MINOR AMENDMENT TO PRELIMINARY PLAT / INFRASTRUCTURE LIST

**Re: Juan Tabo Hills Unit 1, Volterra Village
PR-2018-002118**

The attached submittal is to request that the Infrastructure List be amended to remove all Deferred Sidewalks in front of the Commercial Property located at 1601 Domino Drive, Tract B, and 1601 Domino Drive, Tract C of Volterra Village Subdivision as shown on the attached highlighted exhibit.

INFRASTRUCTURE LIST

City of Albuquerque, Public Works Department, Volterra Village Master Paving Plan. Includes contact information for Mark Goodwin & Associates, P.A. and project details like '756188' and 'M-21-ZH-22-4'.

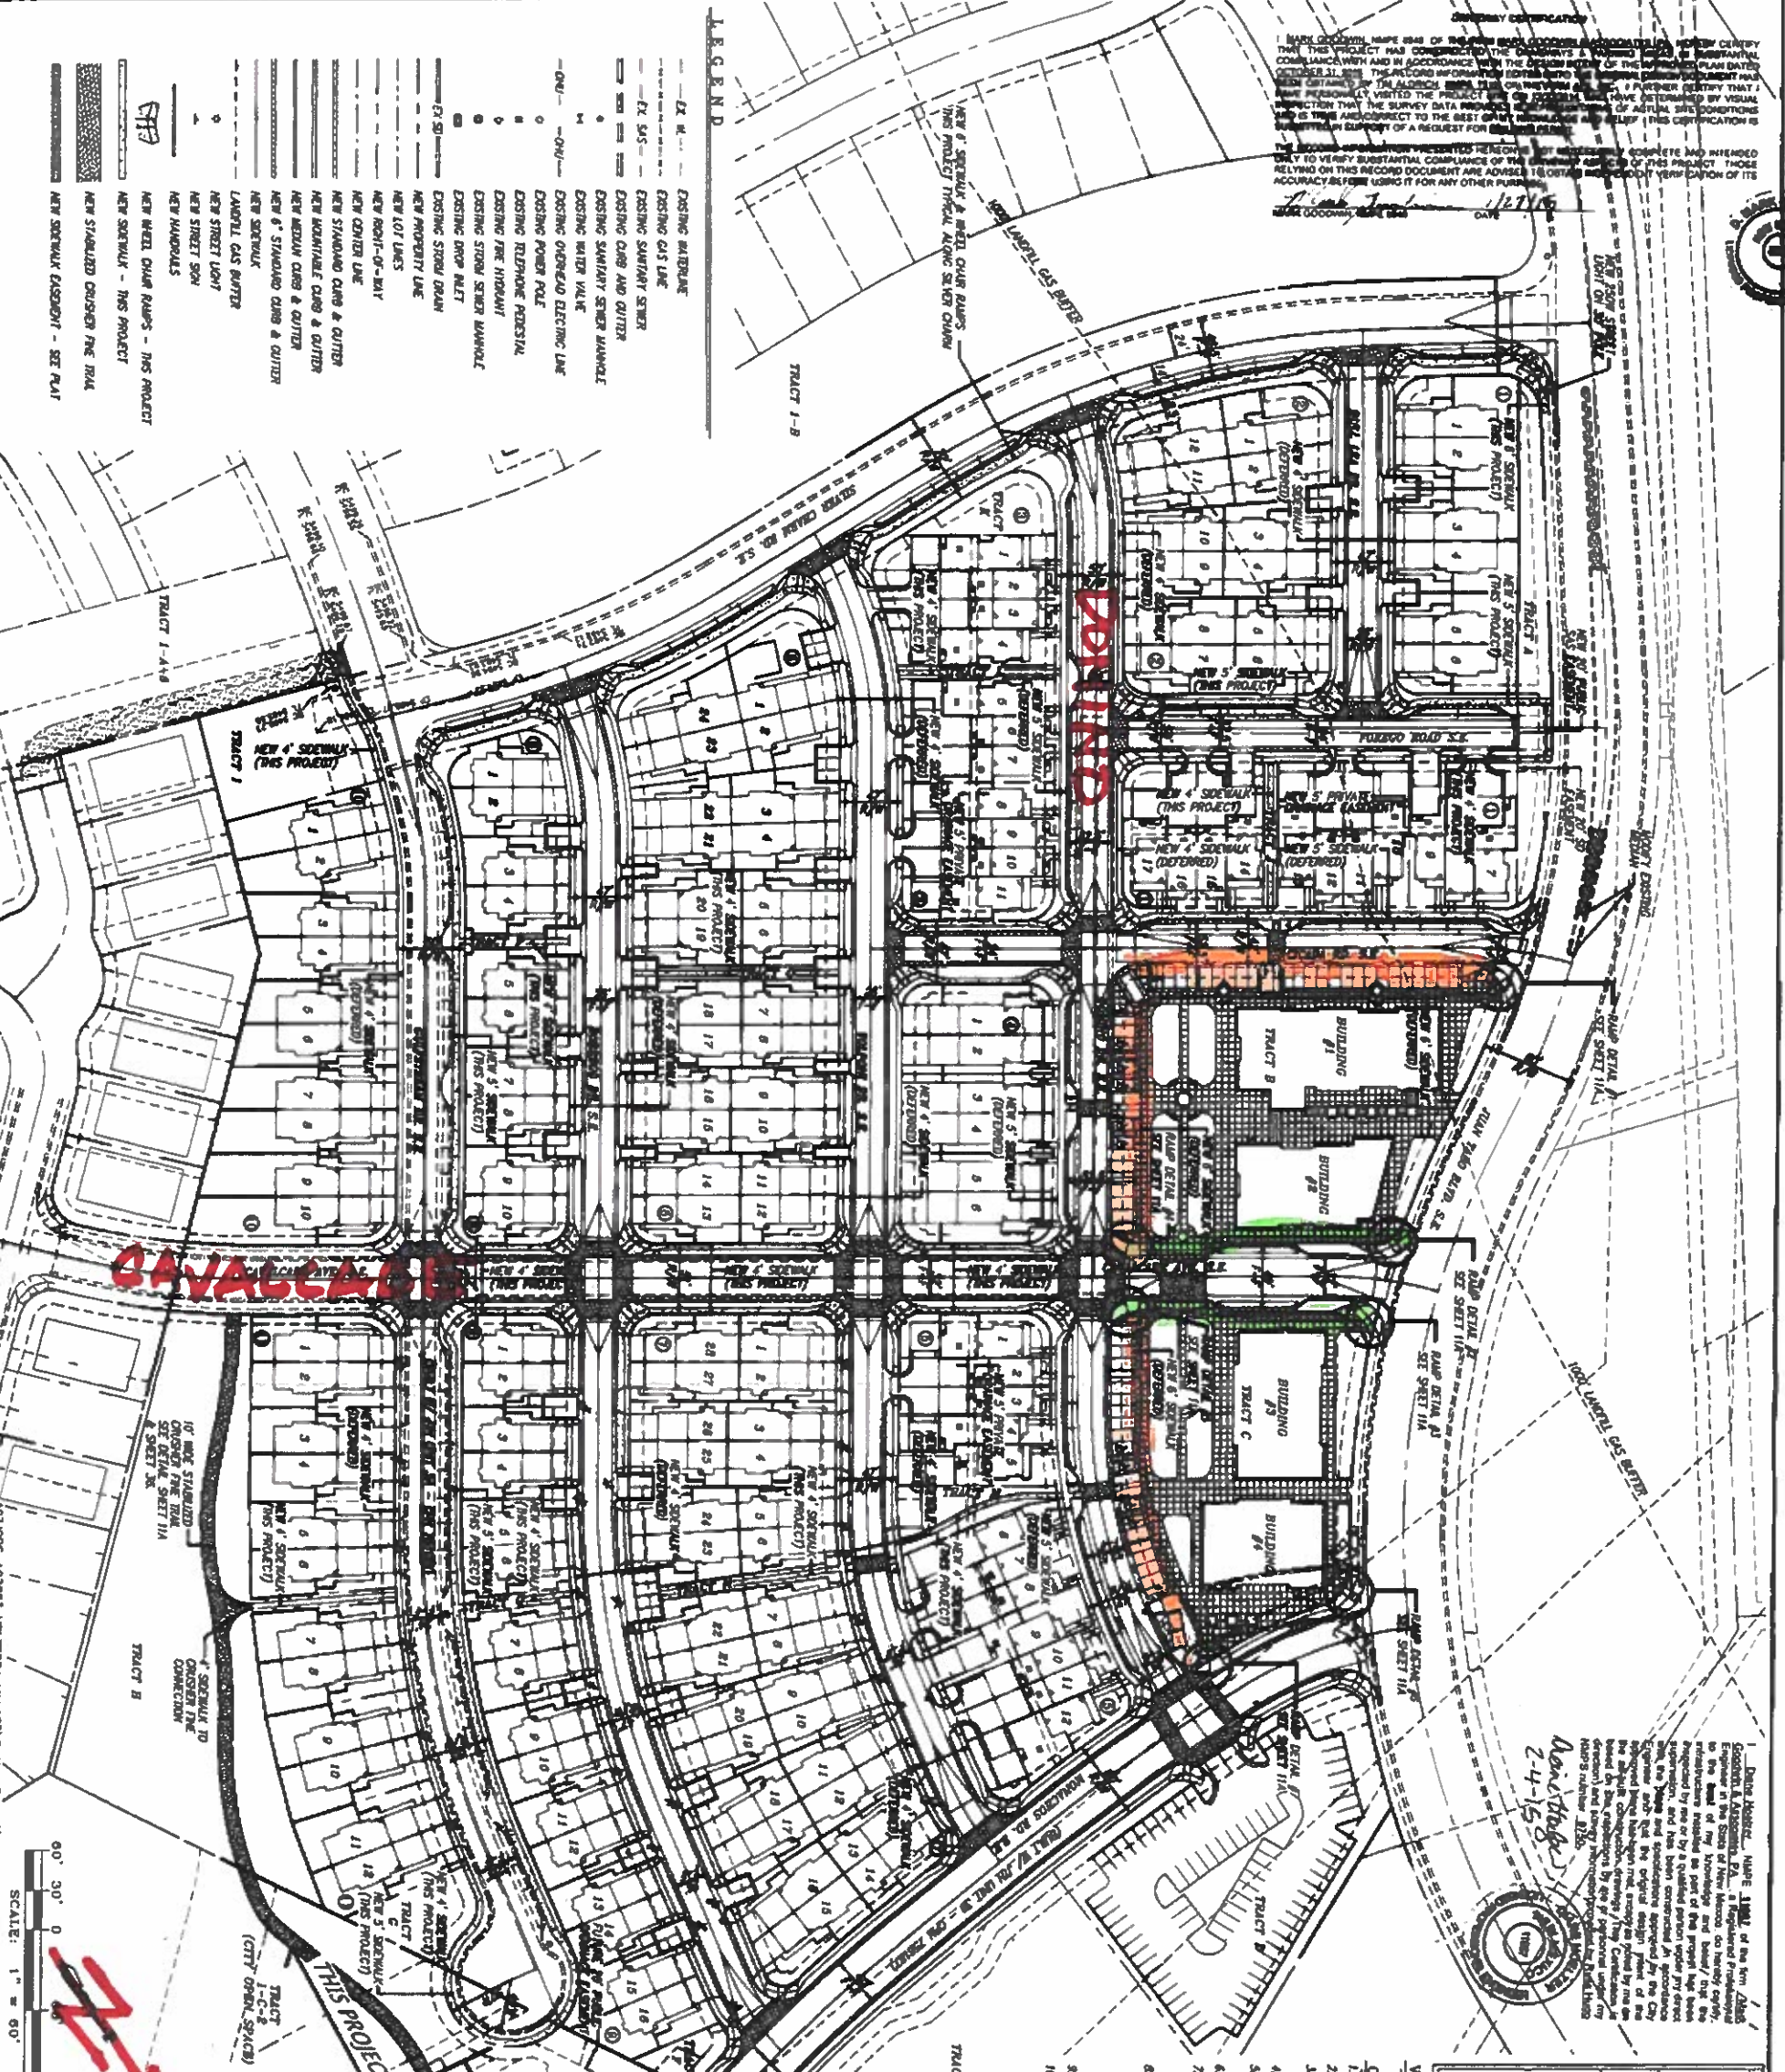
The reason for this request is because any sidewalks that may be constructed on these two tracts is on private property and thus should not be on the Infrastructure List.

THESE ARE ITEMS REMOVED.
12-1-22
